SAFETY EVALUATION BY THE OFFICE OF NUCLEAR REACTOR REGULATION

NEDC-33083P, "TRACG APPLICATION FOR ESBWR"

GE NUCLEAR ENERGY

PROJECT 717 - ESBWR PREAPPLICATION REVIEW

Figure 3.10.1 Time Phases of LOCA Event

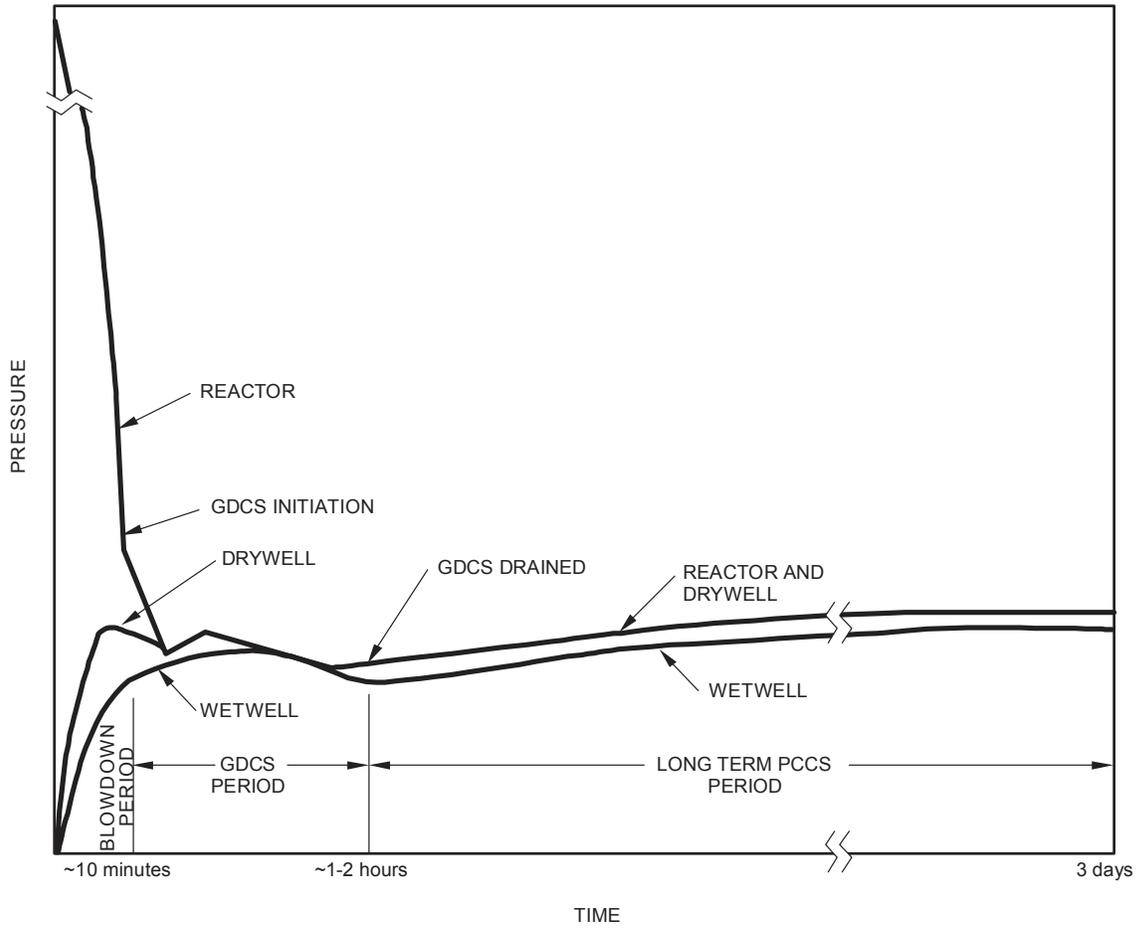
The proposed representation of the ESBWR system, provided in Figure 3.10.1 in Section 8 of this report, is an approximation for the formulation of the top-down scaling relationships. The ESBWR system encompasses two major energy sinks—the SP and the PCCS pool. The SP is the primary sink in the initial portion of the transient. The PCCS pool takes over in the long-term portion of the transient.

removal from the SP resulting in the functional statement quoted from RAI-283. However, this is not the case for the ESBWR and, therefore, the energy partition between the wetwell and the PCCS pool must be represented in the initial formulation of the top-down scaling. By limiting the representation to a single volume system with only one pool, as shown in Figure 3.10.1 in Section 8 of this report, implicit assumptions on the system behavior are imposed and important terms are removed from the governing equations. A more inclusive representation of the system would consider two equations for the vessel (similar to Reference 46, Equations 3.1-6 and 3.1-7), two equations for the wetwell, and one equation for the pressure in the drywell connected to the PCCS pool saturation condition via appropriate heat transfer through the PCCS. This heat transfer would also be a function of the noncondensable distribution dictated by the wetwell governing equations. Such a system of five governing equations would enable a proper representation of the system interactions that GENE has represented by two equations.

Figure 3.7.2.7 Hot Channel Minimum Thermal Margin During GDCS Line Break LOCA.

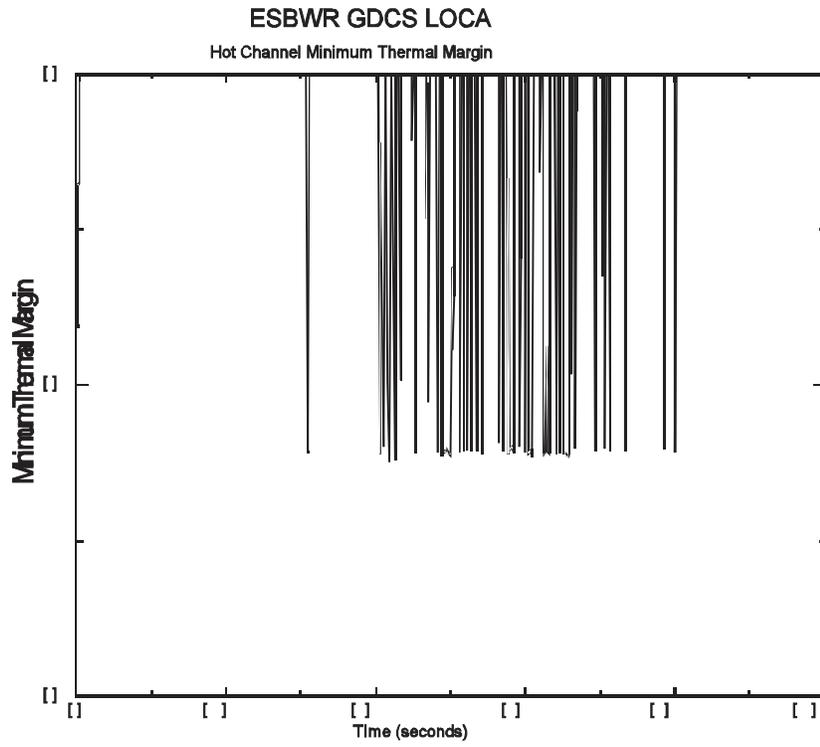
The staff agrees with GENE that a hot channel "drafting" effect does exist. However, defining all of the fuel bundles in ring one as the hot channel would overestimate the effect and the results may tend to be nonconservative. The staff requested further justification. GENE modified TRACG04 and performed the GDCS LOCA base case analysis. The newly calculated minimum thermal margin is shown in Figure 3.7.2.7 in Section 8 of this report. The minimum value of the thermal margin is above 2.0 throughout the transient, demonstrating that film boiling does not occur. Based on these calculations, the staff agrees with GENE that no core heatup is predicted during a LOCA event.

Figure 3.7.2.8 Drywell Pressure With or Without Feedwater Mass And Energy.

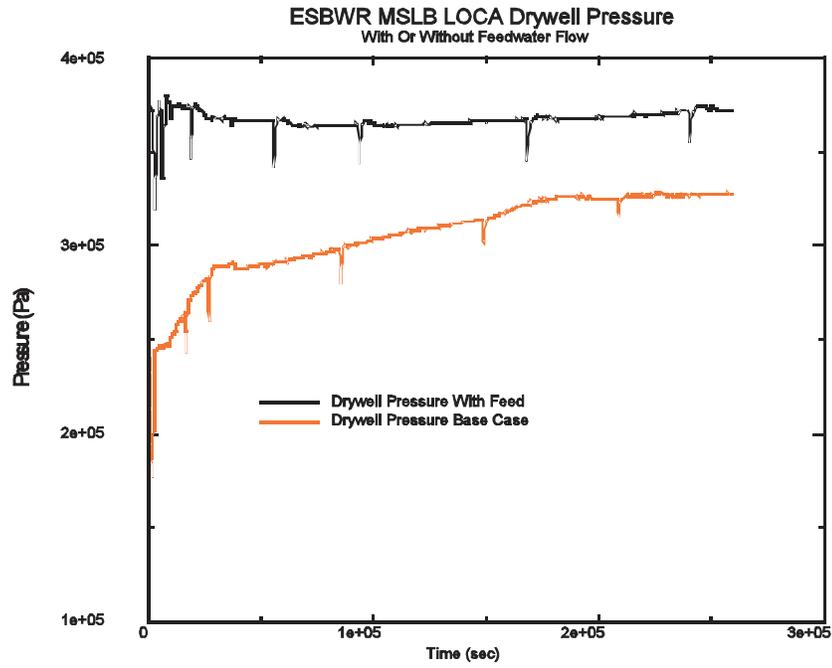
heater train, the staff assumed that the feedwater injection lasts for 600 seconds and the temperature ramps down linearly from the initial feedwater temperature to the saturation temperature at the containment design pressure limit. The calculation was done using the baseline MSLB LOCA model. The result is shown in Figure 3.7.2.8 in Section 8 of this report. The peak drywell pressure of [[]] occurs about [[]] into the transient and is greater than the bounding value calculated by GENE in Reference 11, [[]]. Consequently, GENE performed additional analyses in response to the staff's concern. GENE assumed that the hot water residing in the feedwater heater system (98,144 kg, 215,917 lb) prior to the LOCA is injected into the RPV [[]]. Using the baseline MSLB model, GENE predicted a [[]] peak drywell pressure increase. The results show the feedwater mass and energy release during the MSLB LOCA increases the peak drywell pressure by about [[]]. There is also a possibility that the wetwell volume is flooded and the noncondensable gas is purged to the drywell. Should significant amounts of noncondensable gas be discharged into the drywell volume, the PCCS performance may be degraded.

Figure 3.7.2.20 Wetwell Total Pressure and Non-Condensable Partial Pressure.

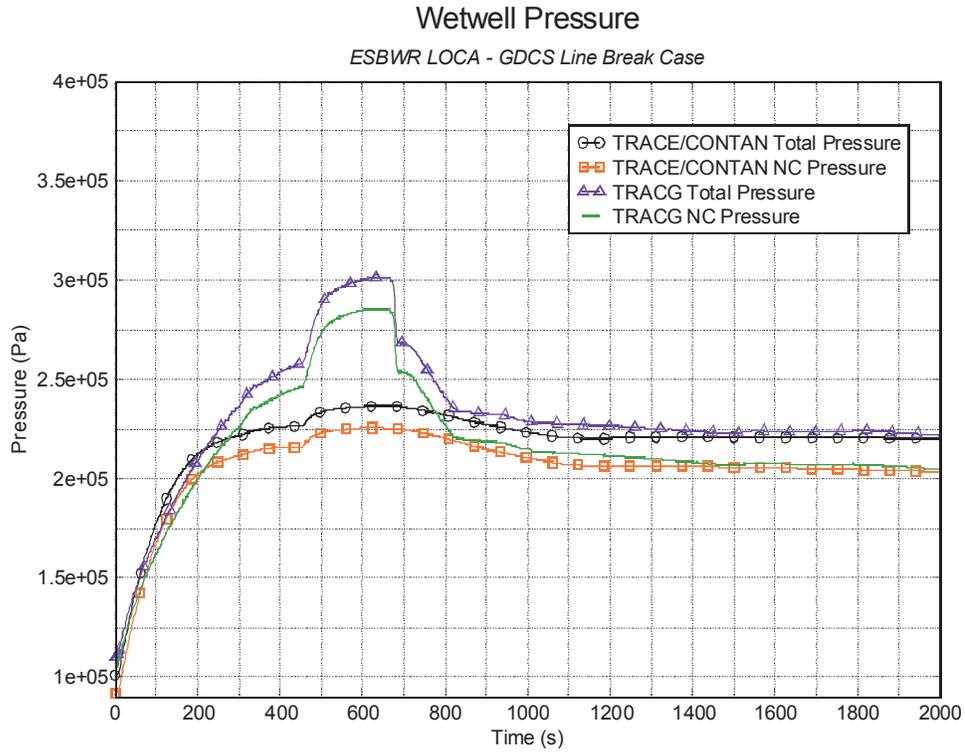
Figure 3.7.2.20, indicates that the total pressure in the wetwell increases primarily due to the transfer of noncondensibles through the drywell to wetwell vents. The dominant mass transfer through the wetwell liquid is the noncondensable gases which accumulate in the wetwell air space. The TRACG code predicts higher pressure (by about 0.75 bar) at about 670 seconds.

Figure 3.7.2.28 MSLB Drywell Total Pressure.

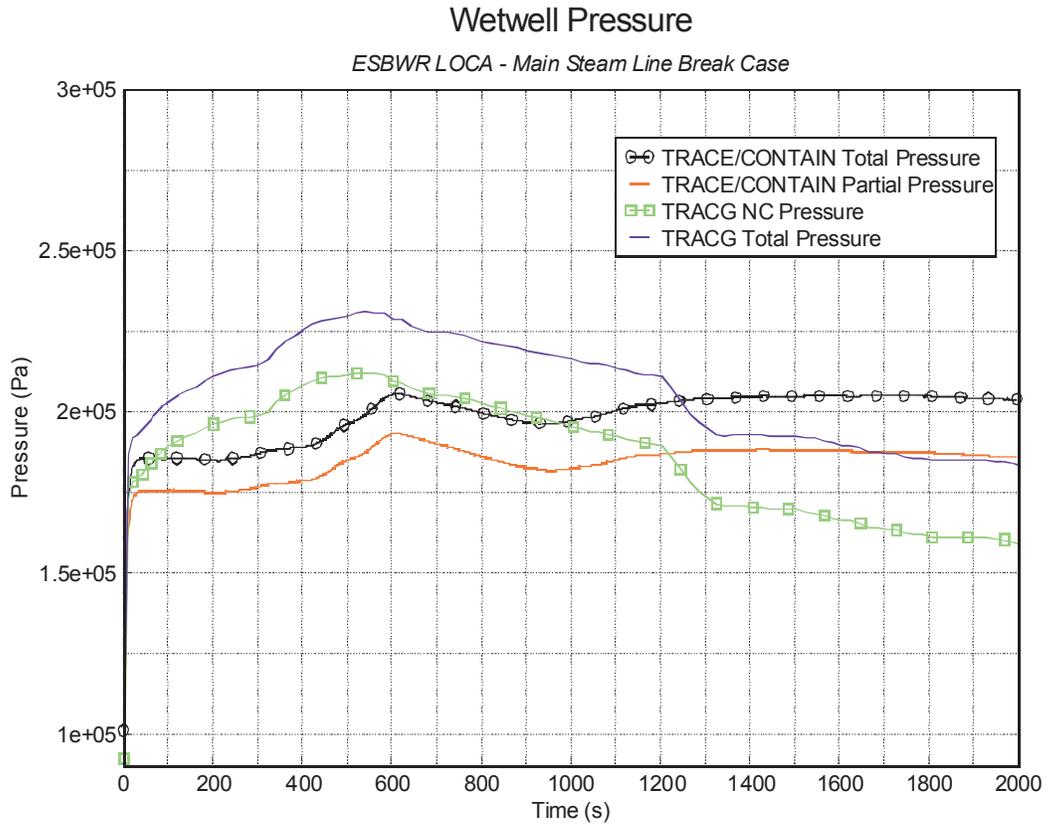
The upper drywell total pressures calculated by both TRACG and TRACE/CONTAIN are shown in Figure 3.7.2.28 in Section 8 of this report. The peak pressure calculated by TRACG during the first 2000 seconds is much higher than that calculated by TRACE/CONTAIN. However, it is still below the design limit. The difference in the calculations appears to be caused by different nodalization schemes used for the two codes with the result that the TRACE/CONTAIN calculation tends to predict more mixing than TRACG.

Figure 3.7.2.29 MSLB Wetwell Total Pressure And Noncondensable Partial Pressure.

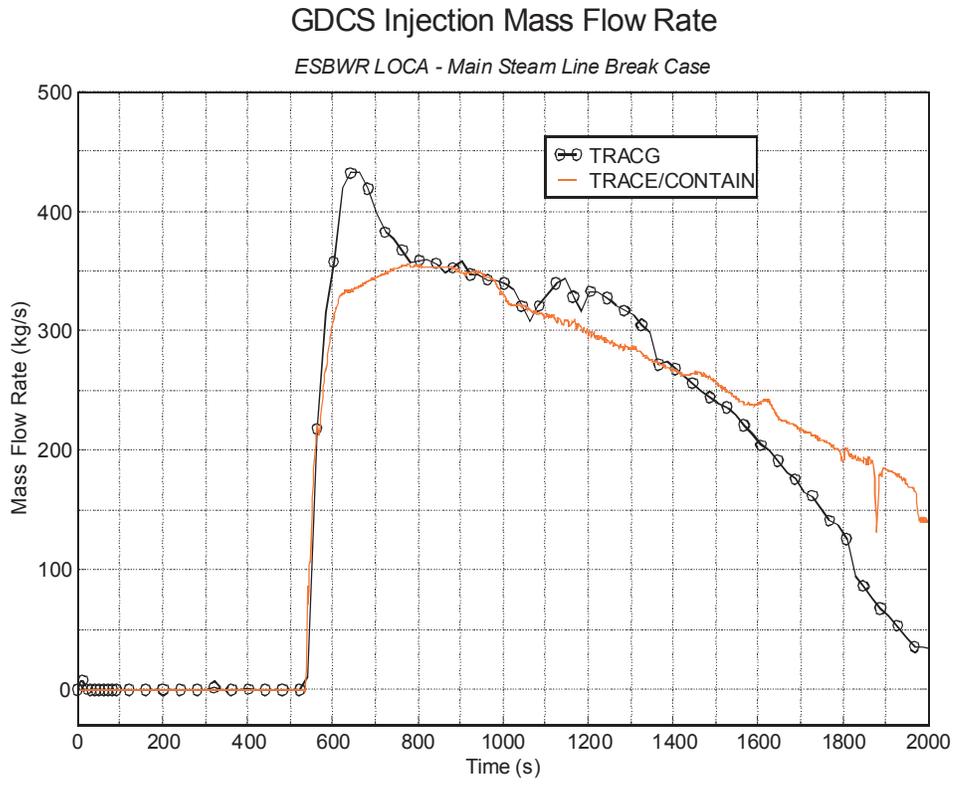
Similar to the drywell pressure prediction, TRACG predicts a higher wetwell pressure peak value. As shown in Figure 3.7.2.29 in Section 8 of this report, the wetwell pressure calculated by TRACG peaks at about 550 seconds. The TRACE/CONTAIN peak value is much lower, demonstrating that TRACG is possibly more conservative in terms of calculating the wetwell pressure load.

Figure 3.7.2.35 BDLB LOCA Core Average Channel Void Fraction.

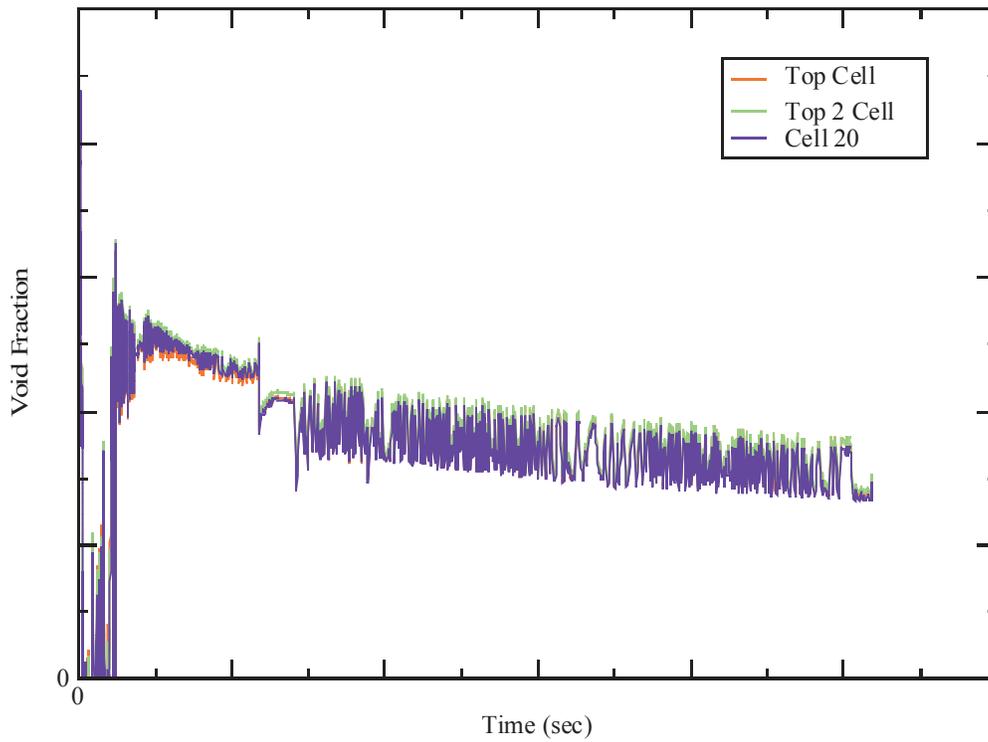
However, the in-channel two-phase level did not drop below TAF. As shown in Figure 3.7.2.35 in Section 8 of this report, the top node of the average channel component active fuel region experienced a maximum void fraction of about 65%. Except for the bypass region, the core remains covered.
